ZU1 SYSTEM BLOCK DIAGRAM

PROJECT : ZU1

Quanta Computer Inc.

Size	Document Number	Rev
	CLK_GEN/CK505	3B
Date:	Tuesday, April 10, 2007	Sheet 2 of 39

Clock Generator

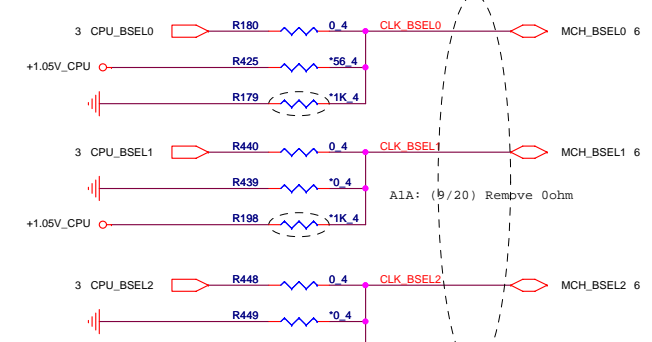
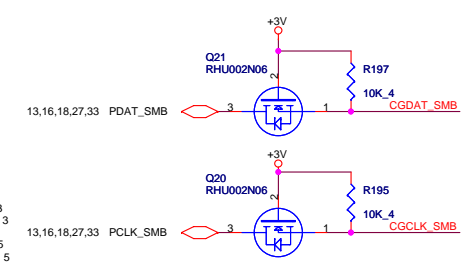
C2A:(12/12)change from +1.05V to +1.25V. Because VDD_IO will drop out when high loading

DDR2 Dual channel A/B PU

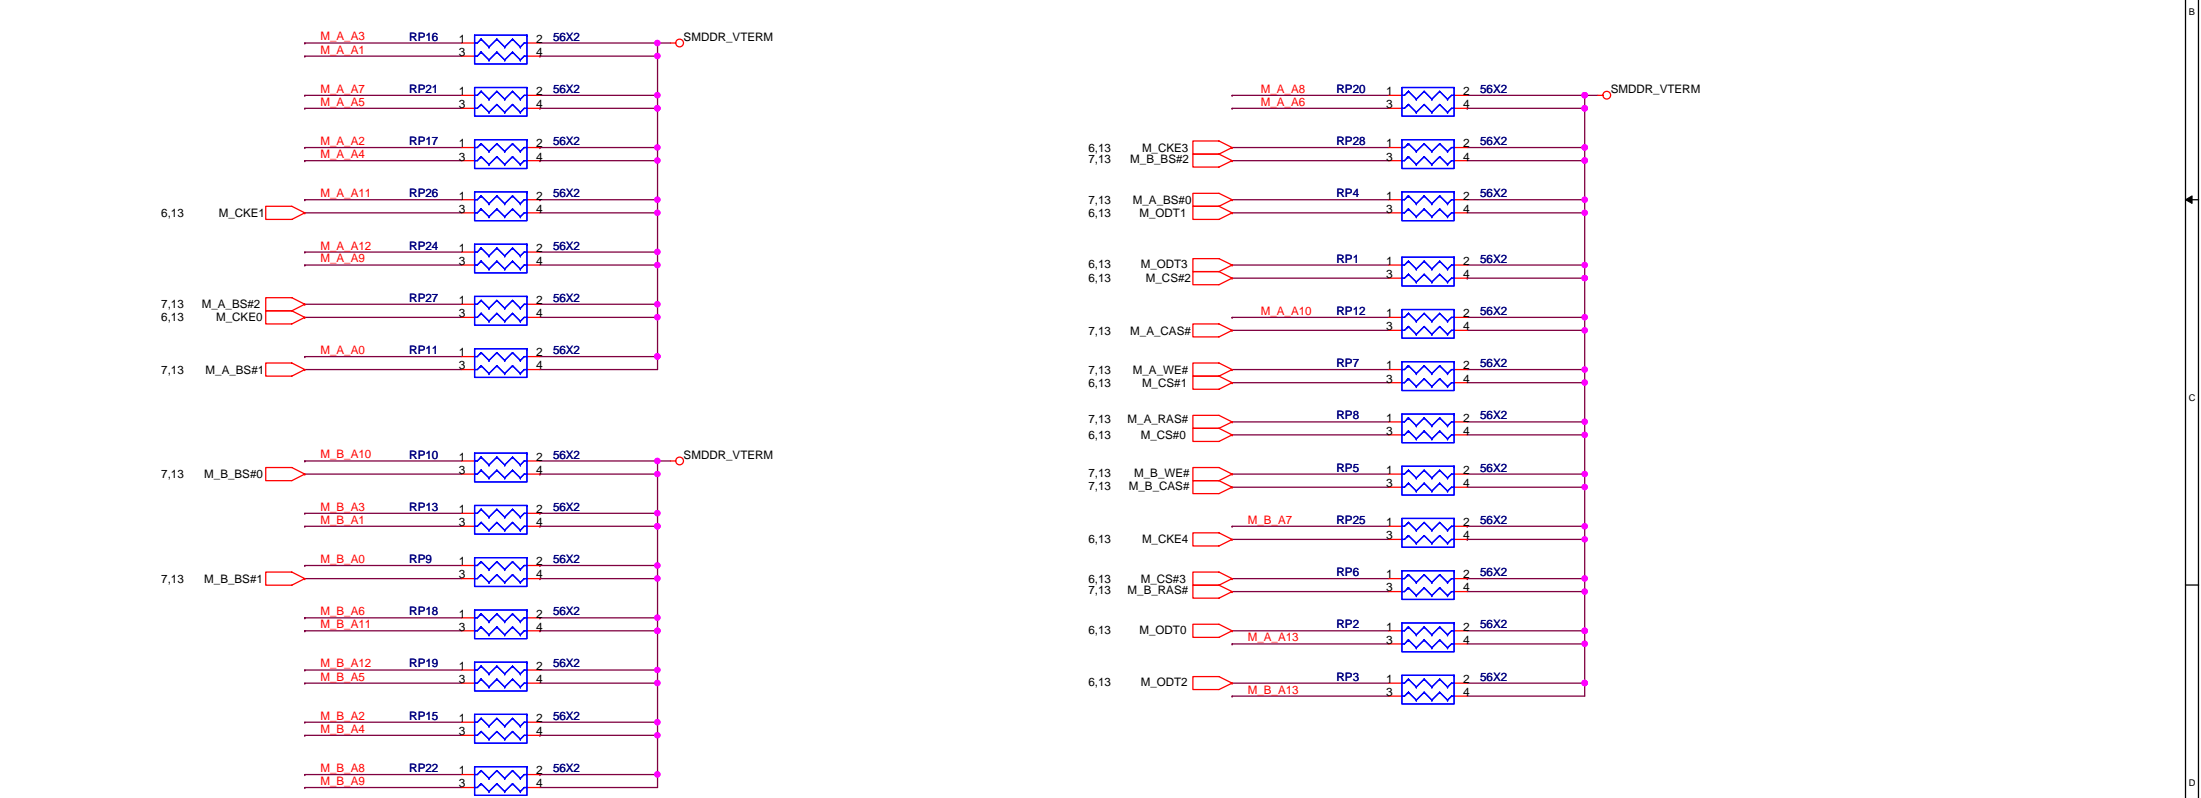
INTEL FAE (08/17)
ADD MA14 FOR DUAL LAYERS RAM

HDA

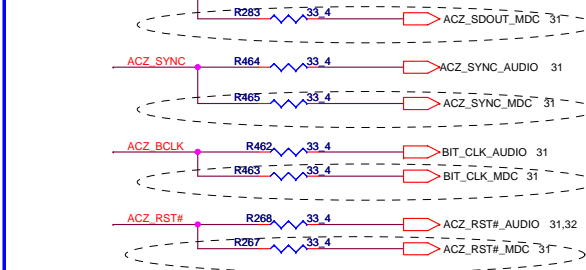
A1A: 9/6 base on Intel design guide, add it.

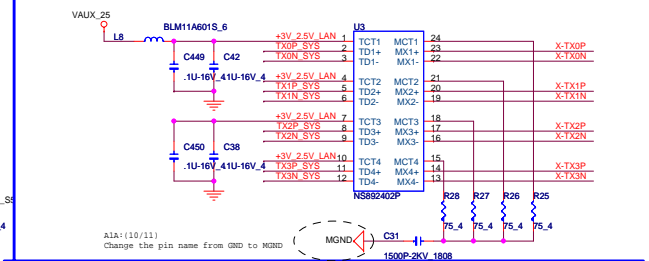
D3A:(1/31) Don't use AL000500005 and use AL000500030 only(change to 8KV solution)

DEBUG PORTS

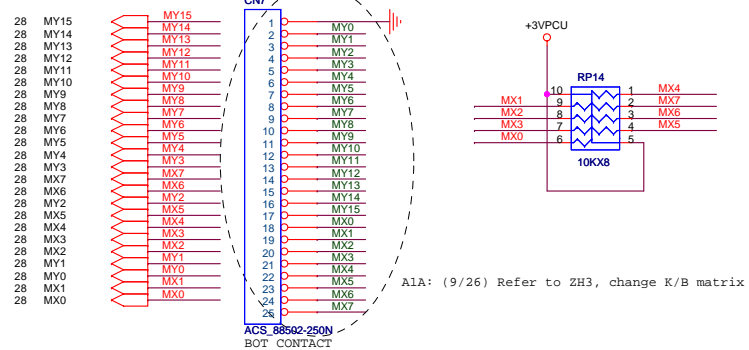
A1A: (10/5): Change LPC debug CONN to DFPC10FR103
E3A: (3/22) confirm with BIOS-CM, no need LPC debug CONN, Remove CM6, R432 footprint to save space for layout.

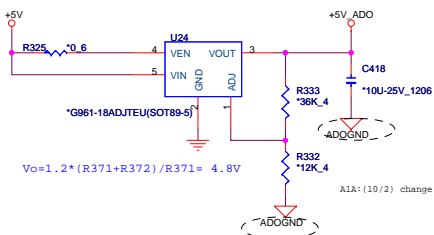
AlA:(9/28) EMI suggest:
Add Additional two more bridge resistor
between ADDGND and GND

A1A:(10/2) change from GND to ADOGND

MDC

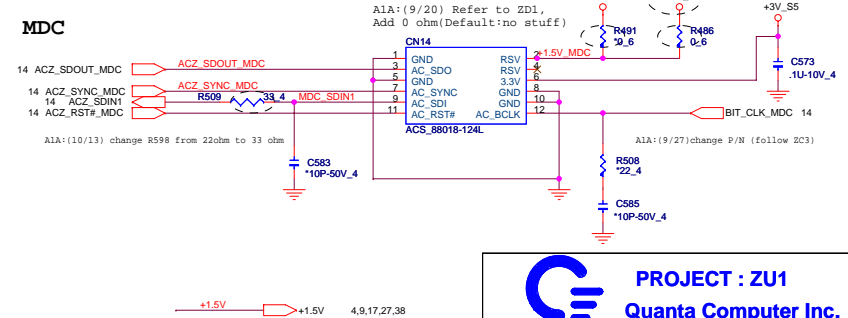
D3A:(1/21) Change CN14/pin 2 from +3v to +3v_s5.
Fix Modem wake from S3 fail issue.
